### **III. Responses to Comments**

## A. Introduction

#### B. Matrix of Comments Received in Response to the Draft EIR

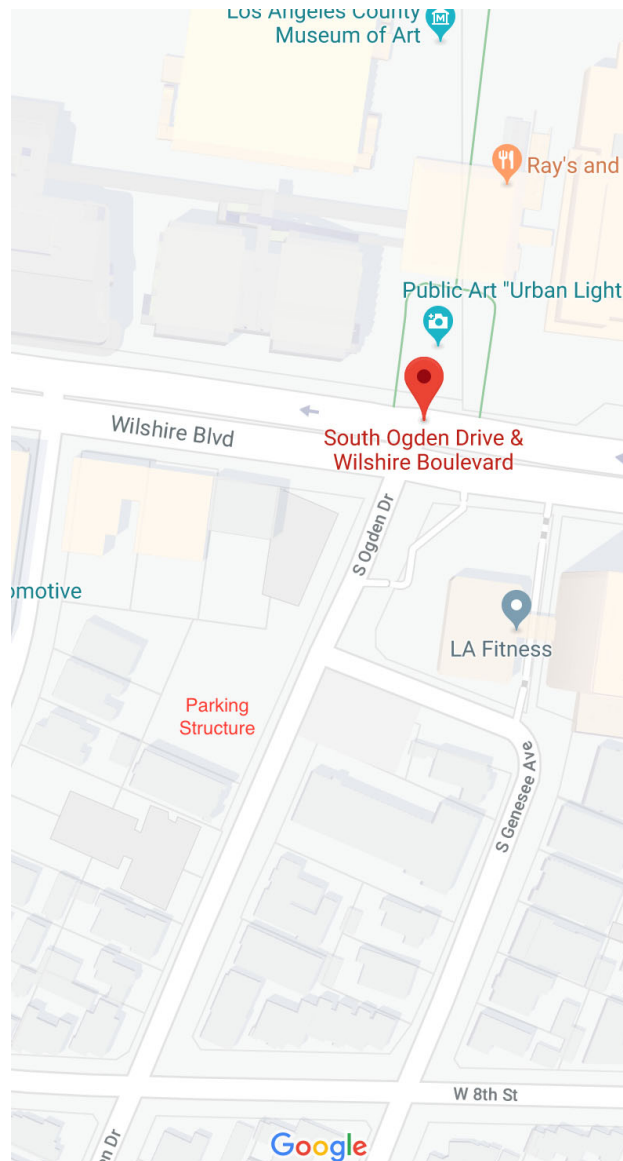
spaces located more than 750 feet from LACMA West or confirmed through lease agreements (i.e., rather than a covenant) during construction.

The analysis of the refinements to the construction assumptions are discussed in Transportation Analysis for the Refined Building for the Permanent Collection Project of the Los Angeles County Museum of Art provided in Appendix FEIR-7 of this Final EIR. Similar to the Parking Study, with implementation of the Construction Parking Management Plan, parking demand during the worst case construction phases for employees and visitors to LACMA and the Academy Museum, as well as the Project construction workers could be accommodated within the Pritzker Garage, North Lawn, Secondary Ogden Lot, and other off-site parking lots. In addition to the on-site spaces, off-site parking spaces were identified in various nearby parking facilities that could accommodate the Project construction worker parking demand. As discussed in Appendix FEIR-7 of this Final EIR, the general contractor conducted an updated parking survey of nearby parking facilities in May 2018 to identify potential parking facilities that could accommodate the parking demand of the construction workers. Several parking facilities in the surrounding areas were identified with more than enough availability to accommodate the construction worker parking demand. It should be noted that the surveys account for the current use of nearby parking facilities by construction workers from the Metro Purple Line Extension, and provide worst-case conditions

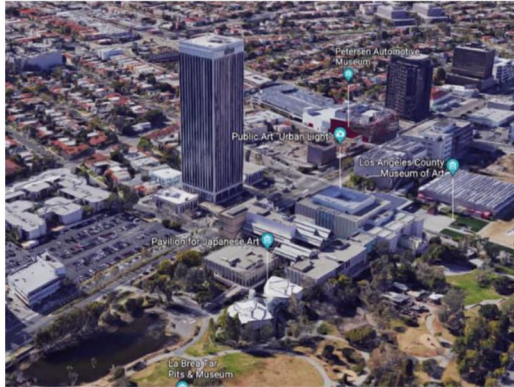
Here, the DEIR understates the scope of the Project, its usage and its concomitant environmental impacts. First, the existing current building footprint is overstated which therefore understates the new Project’s impacts.—the existing 1965 Complex and Americas Building total 383,571 SF of actual building space,<sup>3</sup> not 392,871 SF which is inflated by including the “outdoor-covered area” and citation to AIA regulations not adopted by the County or City. (DEIR II-2, IV.A-49). In truth, the Project’s new footprint spans approximately 880 feet from northwest corner (near rotunda/observation tower) to the southwest corner of the Project (on Spaulding Lot)—57 percent bigger than LACMA East’s current building footprint (560 feet).<sup>4</sup> (DEIR IV.C-72; APP-A 14).

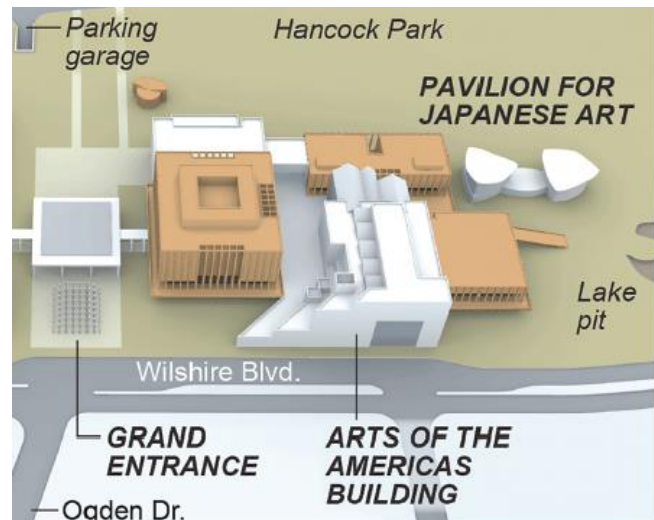
design. The original Petersen and Academy Museum buildings were both originally designed as department stores by different architects and were constructed prior to the LACMA complex in 1965. They are not within the boundary of the original LACMA complex and were not a factor in the analysis of the integrity of this complex.
